**KOLKATA PORT TRUST**  
**HALDIA DOCK COMPLEX**

**Tender No. SDM(P&E)/T/38/2018-2019**

**ADDENDUM - I**

**“Supply, Installation, Testing and Commissioning of 33 kV Over Head Line & Under Ground Cable from Intake Substation to GC Berth Substation for strengthening of power supply arrangement of RMQC-3 of HDC, KoPT”**

KOLKATA PORT TRUST HALDIA DOCK COMPLEX					
SURVEYED.	P.K. ROY	PROP. 11/33 KV OVERHEAD LINE FROM INTAKE SUB-STATION TO MICRO WAVE TOWER/GC BERTH MAIN GATE			
DRN.	P. PATRA				
CHKD.					
(ADMN.)	(I & C.F.)	(RAILWAY)	(P & E)	(P & E)	SCALE : - NTS.
				DATE : 17.05.18	DRG. NO :- ELEC-O/L-1

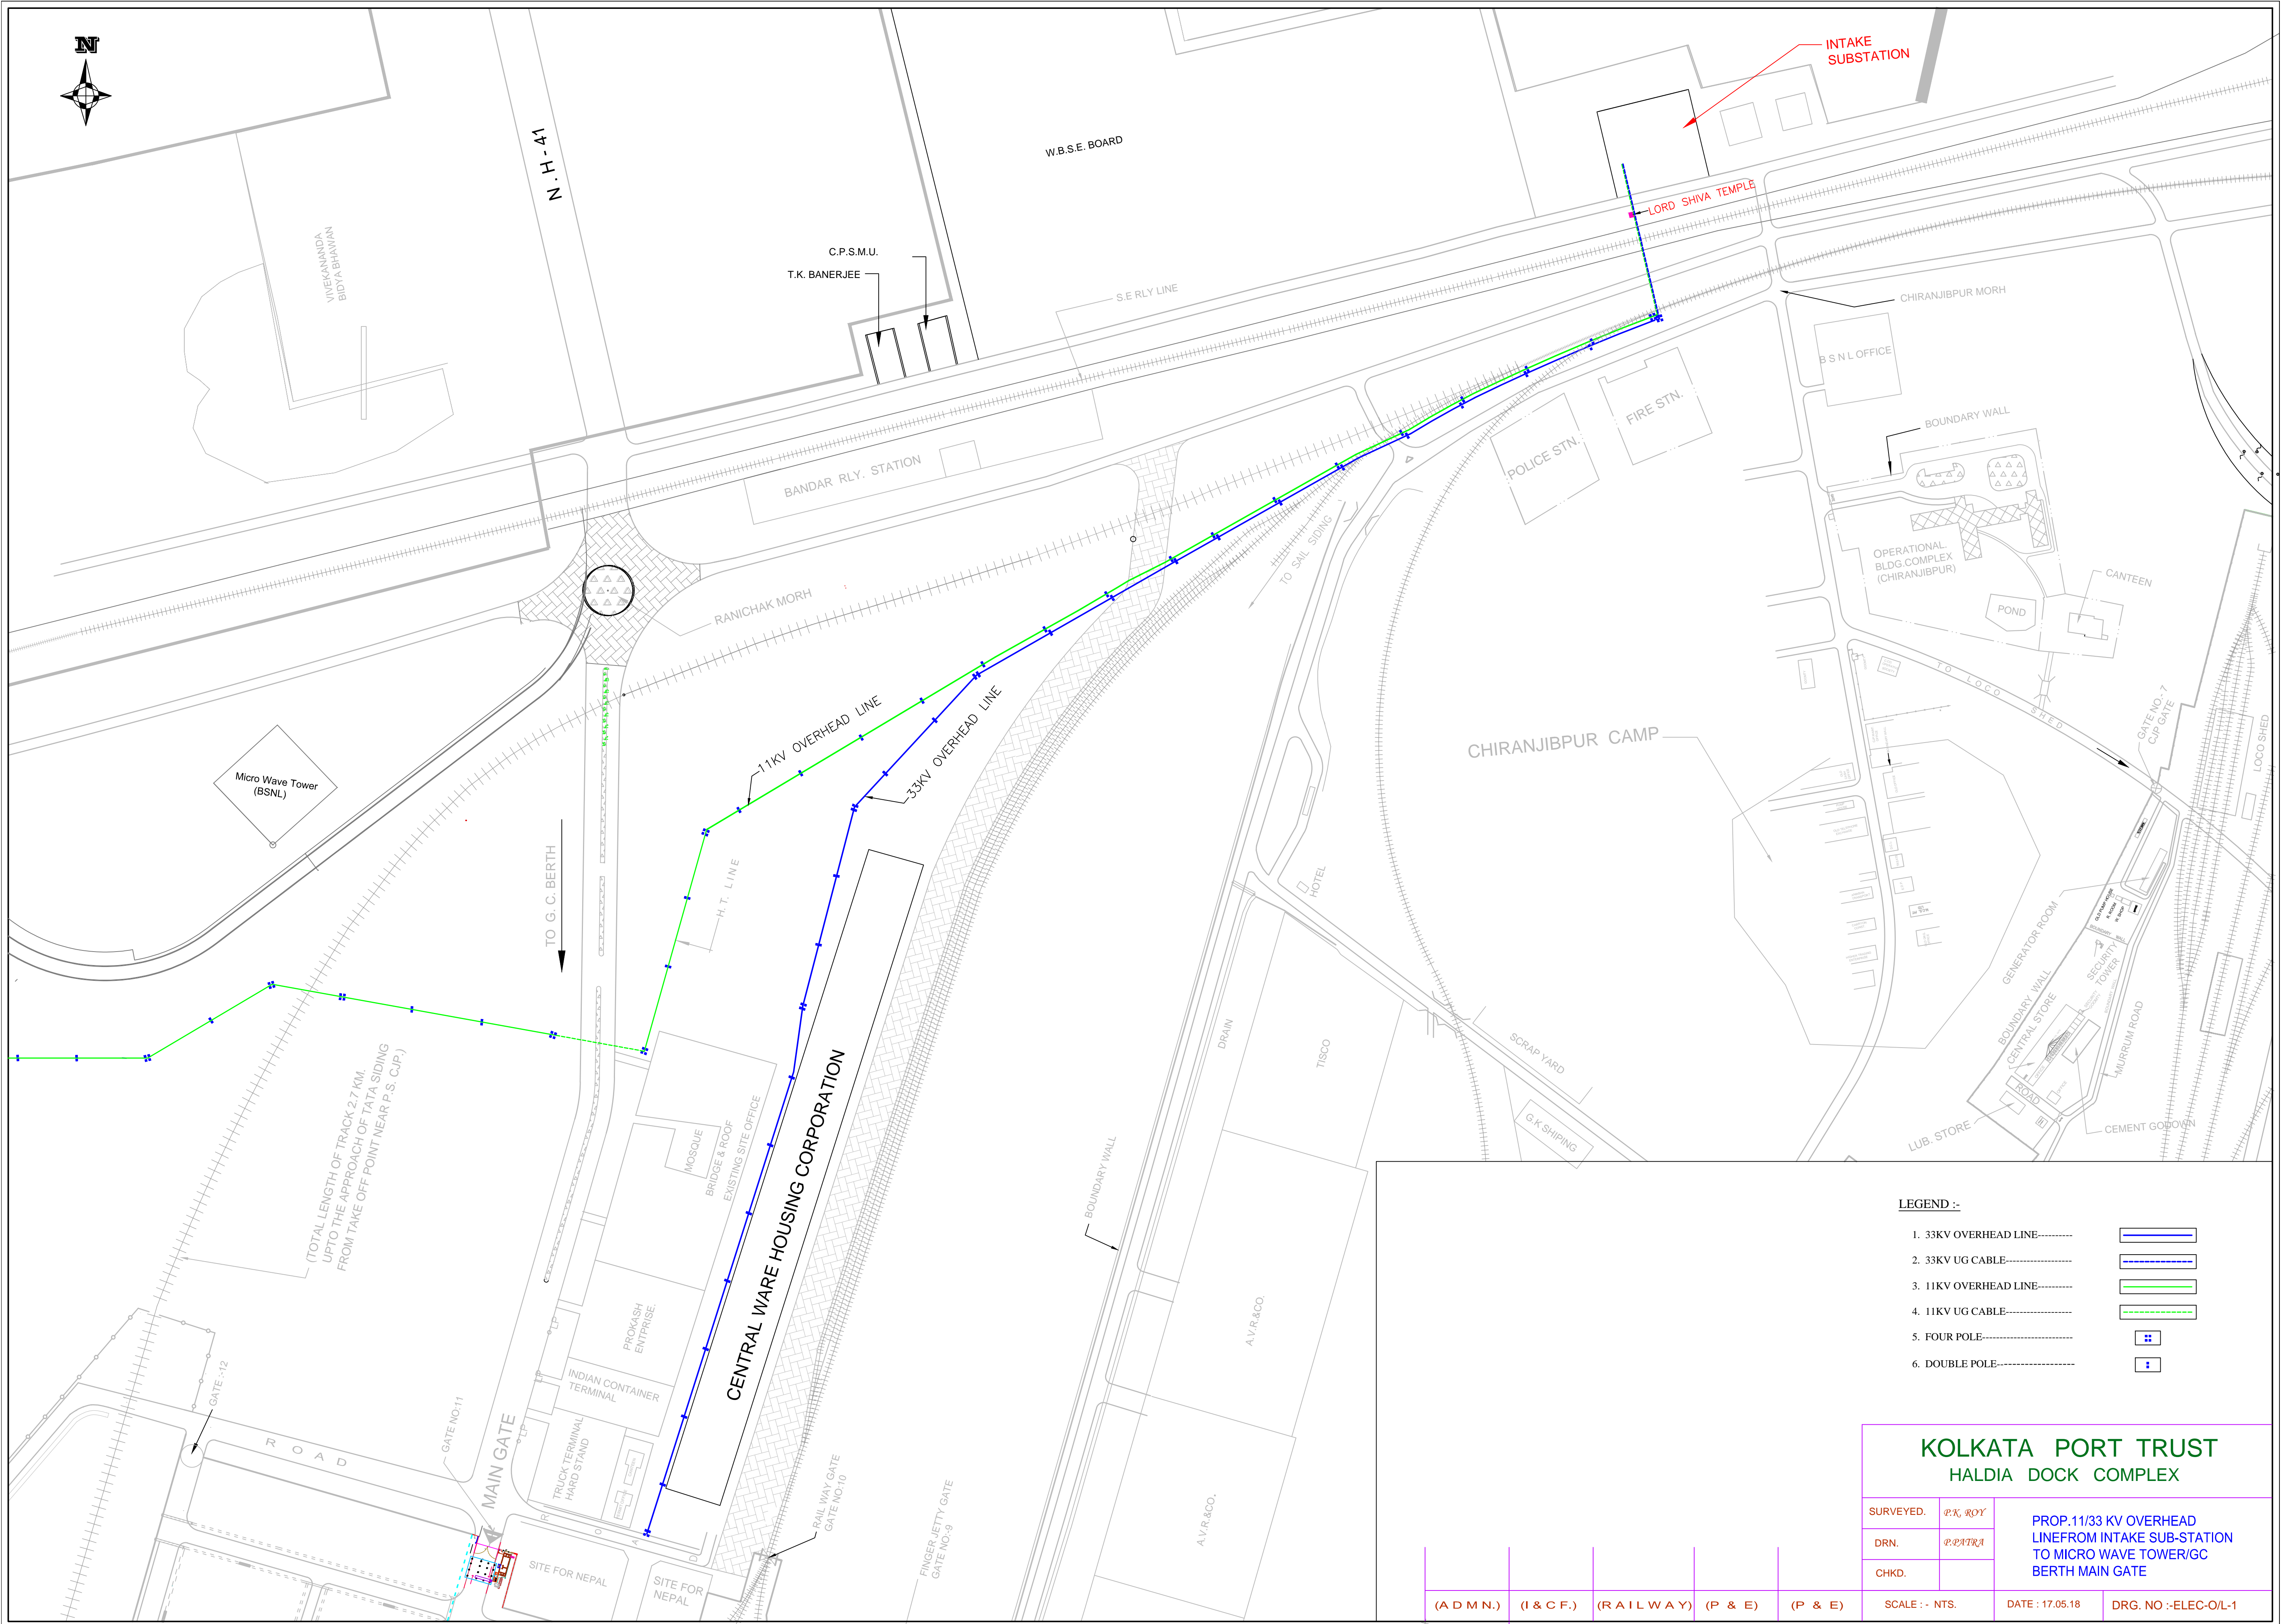
<b>Sl. No.</b>	<b>Page No.</b>	<b>Clause No.</b>	<b>As specified in the Bidding Document</b>	<b>To be deleted &amp; read as / Remarks</b>
1.	--	Table of contents Part-5	Over Head Line route layout [Not uploaded]	Over Head Line route layout [Uploaded]  i) Route layout drawing (Drg.No.ELEC-O/L-1) from Intake Substation to GC berth 4 Pole near Permit office  ii) Route layout drawing (Drg.No.ELEC-O/L-2) from Intake Substation to 4 Pole near CJP Fire Station  iii) Route layout drawing (Drg.No.ELEC-O/L-3) from GC berth 4 Pole near permit office to inside of GC Berth sub-station

Sl. No.	Reference	Queries of the firms	HDC, KoPT's Clarifications
7.		<b>Overhead Line Layout:</b> Kindly provide the proposed 33 kV Overhead line layout as mentioned in the table of contents.	Please refer Route layout drawing (Drg.No.ELEC-O/L-1) from Intake Substation to GC berth 4 Pole near Permit office as per addendum.

Drg No: - ELEC-0/L-3

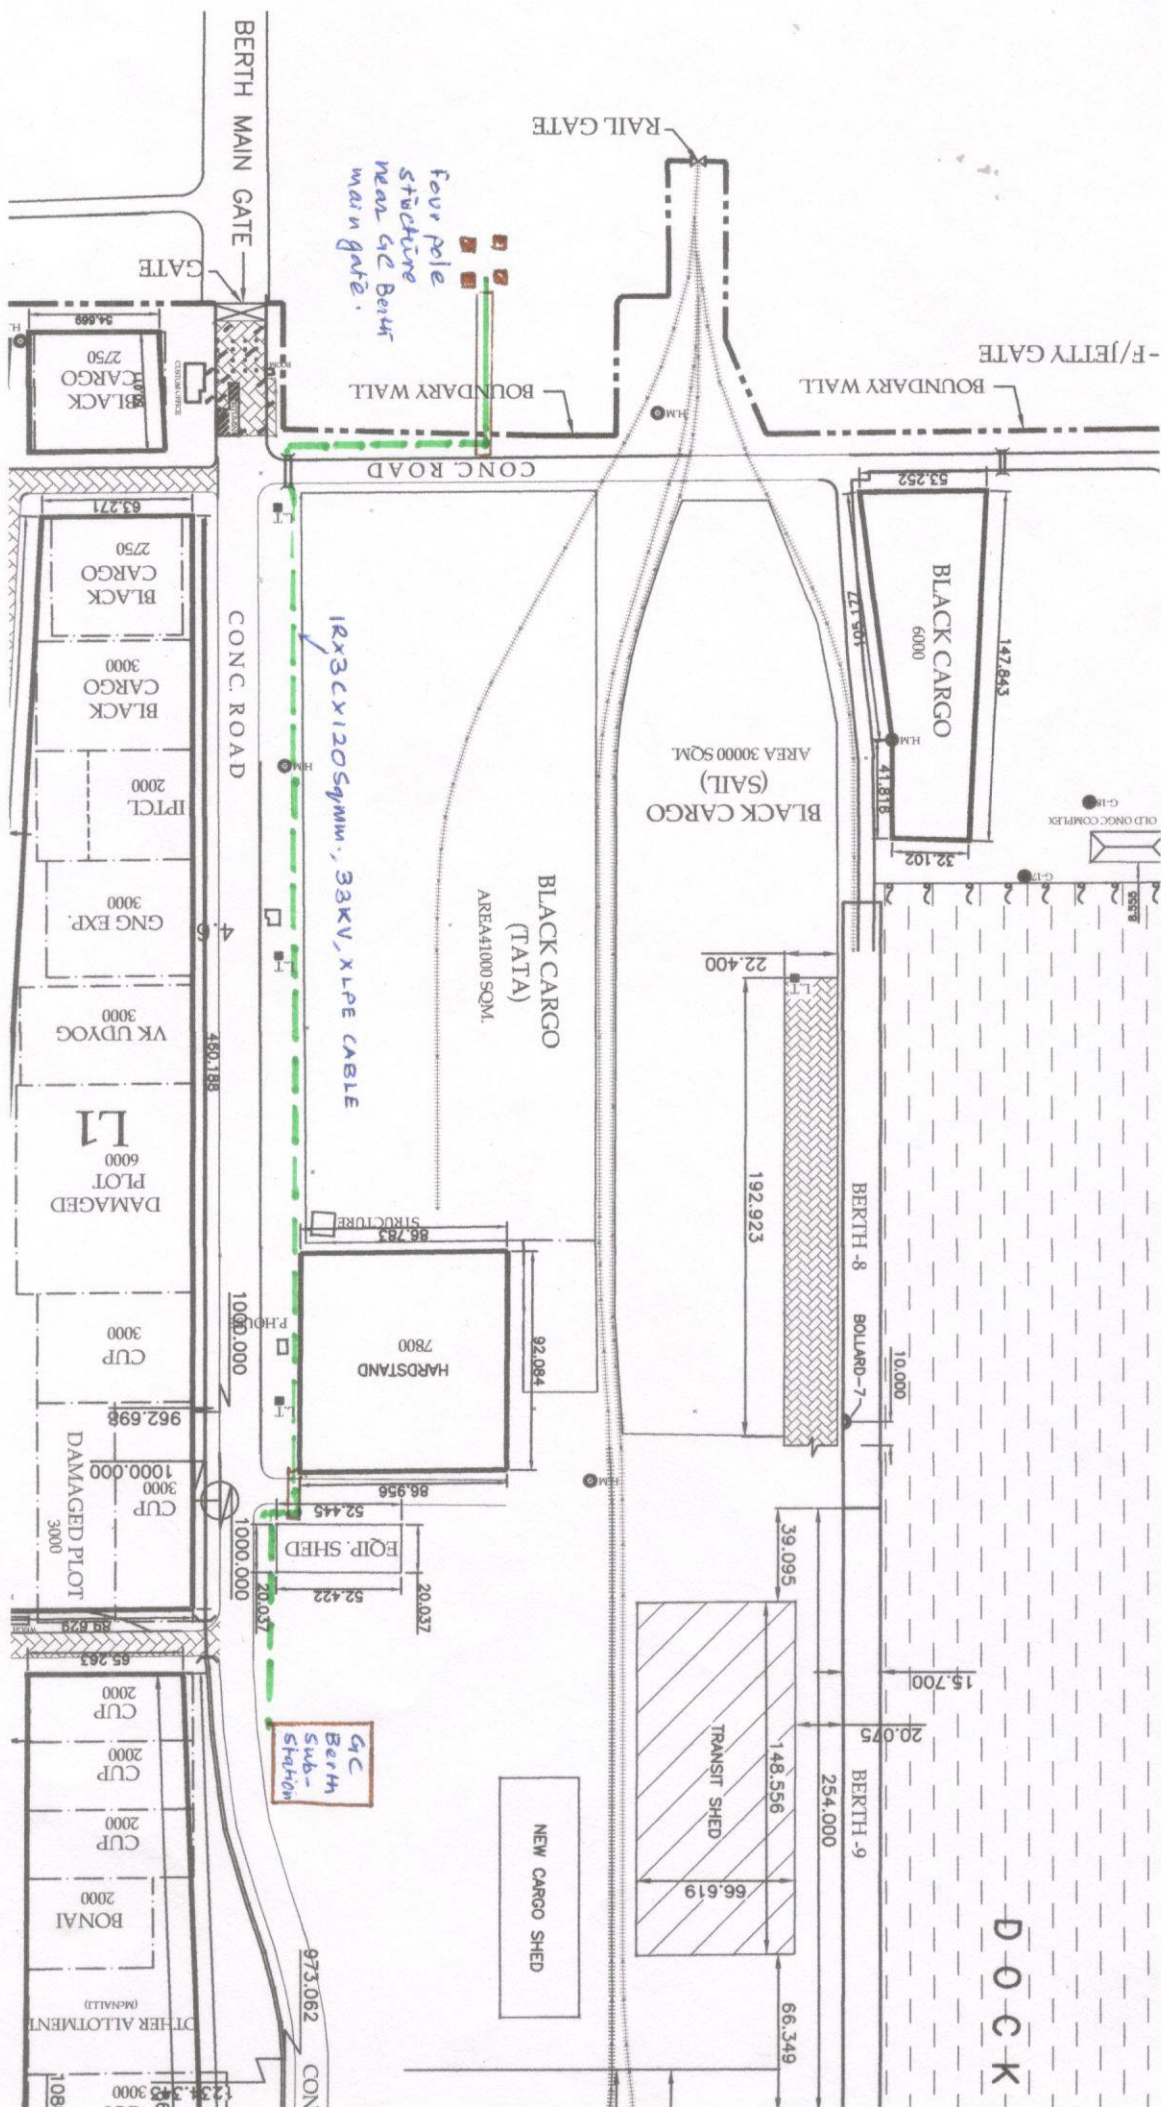
8.		<b>Approved make:</b> Kindly provide approved make of insulator, ACSR Conductor & Hardware fittings.	Please see the addendum.
9.		<b>GC Berth:</b> Kindly provide route layout from GC Berth 4pole near permit office to inside of GC Berth sub-station.	Please refer Route layout drawing (Drg.No.ELEC-O/L-3) from GC berth 4 Pole near permit office to inside of GC Berth sub-station as per addendum.
